ML-271

Service Letter ML-271

TECHNICAL TIPS

DATE: April 1986

Figure 1. Oil Drain Hole

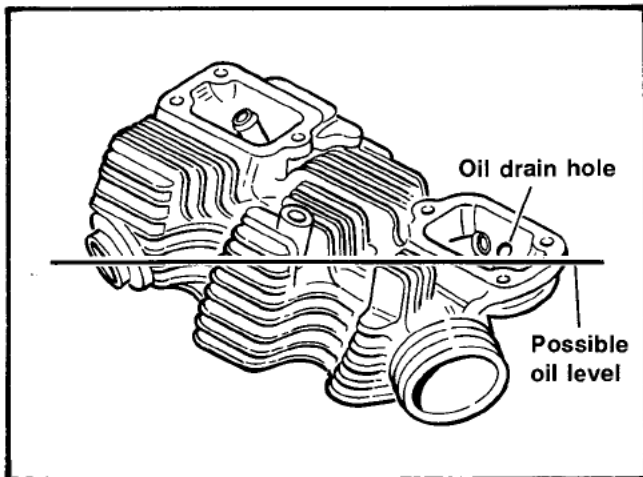
6. Has your 1984 and early 1985 XL customer complained of a valve train clatter, power loss and backfiring through exhaust system after a short trip?

This could be a sign that an exhaust valve is beginning to stick. See Figure 1. If this is the case hold the head at the approximate angle it sits on the cylinder. You may observe that the oil drain hole is almost even with the top of the valve guide. This drain hole should be lowered to keep oil level well below the top of the guide. Lower hole with grinding tool.

Figure 2. Clutch Pushrod

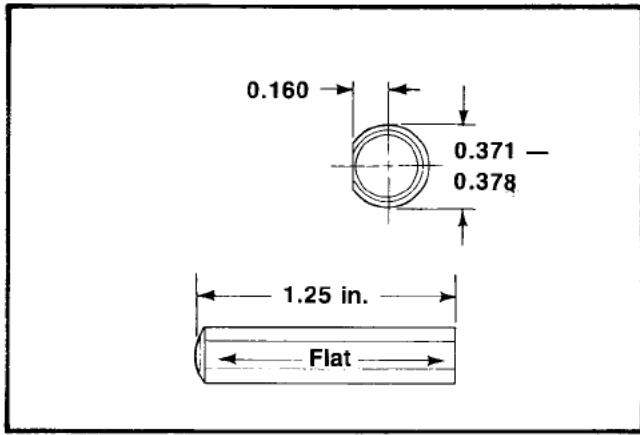
9. Does your customer with a late 1984 vehicle have chronic oil leaks at the rear of the primary case?

This leak may seem to be coming from the O.D. or I.D. of the inner primary bearing or on 4-speed vehicles, from the starter motor housing or around the head of the starter drive actuator arm mounting screw on top of the primary housing.

The inner primary vents through the mainshaft and out the transmission vent hole or hose by means of a flat which is ground the length of the clutch pushrods. A small percentage of late 1984 vehicles did not have a flat on the pushrod closest to the adjuster.

See Figure 2. If there is no flat on the clutch pushrod, grind one the length of the pushrod.

Figure 3. Four Speed Shifter Shaft

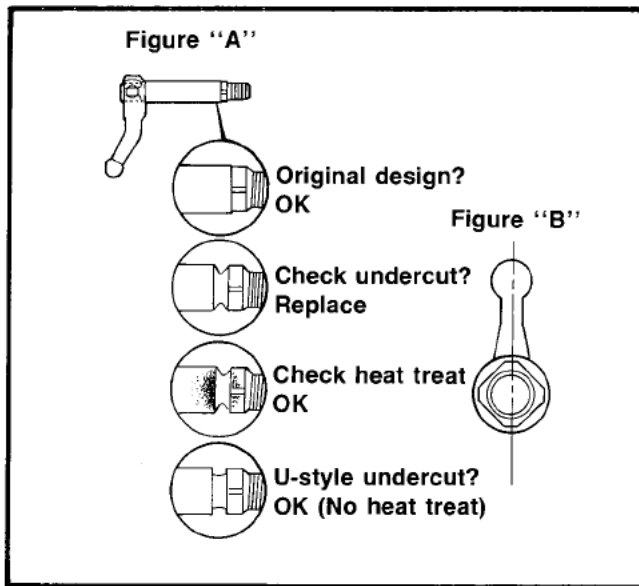
12. Does your 1985 FXR or FXRT customer complain of shifter difficulties after vehicle has reached operating temperatures?
13. Have your new customers of rear belt drive vehicles complained of a "chirping" noise under normal driving conditions?
14. Have you experienced recurring main drive gear oil leaks on 1982 and later 4-speed vehicles?

See Figure 3. Inspect shifter shaft in transmission top cover. Part No. 34652-80. Check for twist or improper indexing of shifter shaft finger ball to cam end.

Using a straight-edge, as shown in Figure "B", the ball end should be split in half. If it is not split in half the shaft is twisted or improperly indexed. Replace shifter shaft.

Primary case expansion reduces end play of shifter shaft, if lever is too close to primary cover. This growth could cause drag and reduce shifting performance. Relocate lever, increasing end play of the primary shifter shaft. Check end play while vehicle is at operating temperature.

Figure 4. Main Drive Gear and Spacer

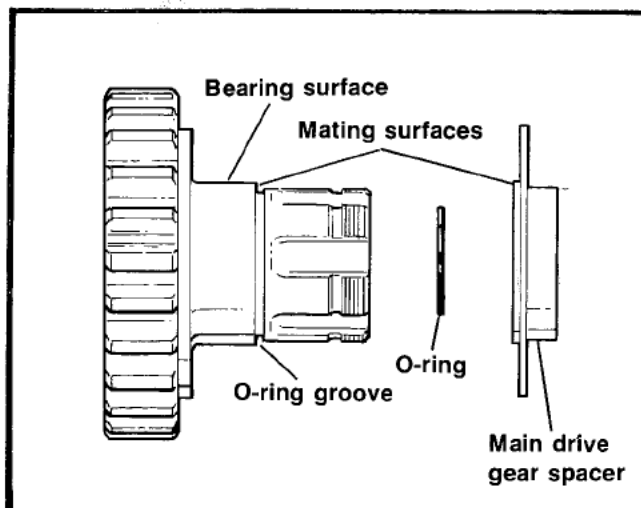
Oil passing between the main drive gear spacer and the main drive gear (spline leaks).

- (1) Remove inner primary. See DRIVE section in Service Manual.
- (2) Drain lubricant from transmission.
- (3) Remove main drive gear spacer and seal.
- (4) Clean main drive gear to spacer mating surfaces so they are oil free.
- (5) The main drive gear spacer you removed should be replaced with the appropriate new spacer:
Rear Belt Drive – P.N. 35070-84
Rear Chain Drive – P.N. 35079-84
- (6) See Figure 4. Apply a light coat of machinist's blue to the main drive gear spacer's mating surface.
- (7) Install spacer on the main drive gear and rotate spacer to establish the location of the contact patch. Remove spacer and verify this contact area. There should be 360° of even contact. If a good

mating surface cannot be established try another spacer, because the chamfer may be too large. If you have any questions contact the Technical Service Department.

Install O-ring part no. 1114. **Do not use a substitute.** Take care to protect the O-ring from the splined threads of the main drive gear. Use masking tape on the splines. Install the O-ring in groove directly against shoulder. Coat O-ring with a light grease such as vaseline.

Fig. 2 Cam Compartment

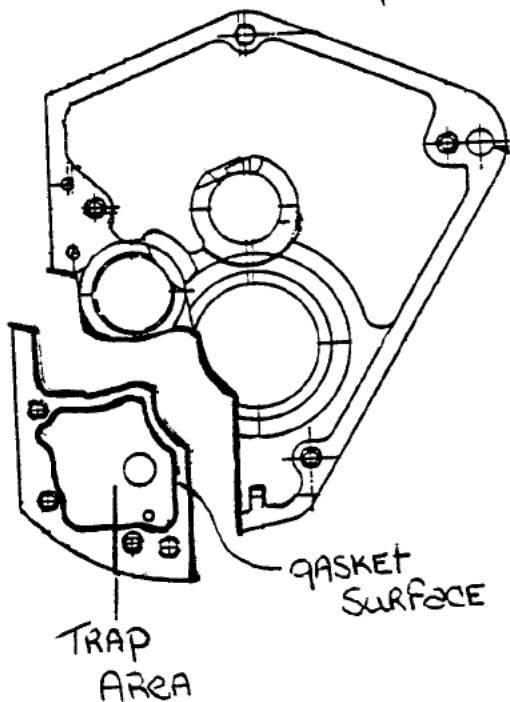
Now that your anticipation has built to a fevers pitch. Go ahead, pull off the pump, take off that cam cover. But know what you're looking for.

- 1.) Oil pump return pockets for damage, grooves, a sheared drive gear key.
- 2.) A damaged breather gear or pocket or out of time. Don't just look at it, pull it out.
- 3.) A damaged gasket surface between the trap area and the cam compartment. See figure (2).
- 4.) A cracked or porous cam cover.
- 5.) A plugged evacuator hole in the trap compartment.
- 6.) A plugged return passage to the return gears.

If you haven't found it by now, don't put it back together, call us first. Maybe we have some new revelation that might solve the problem.
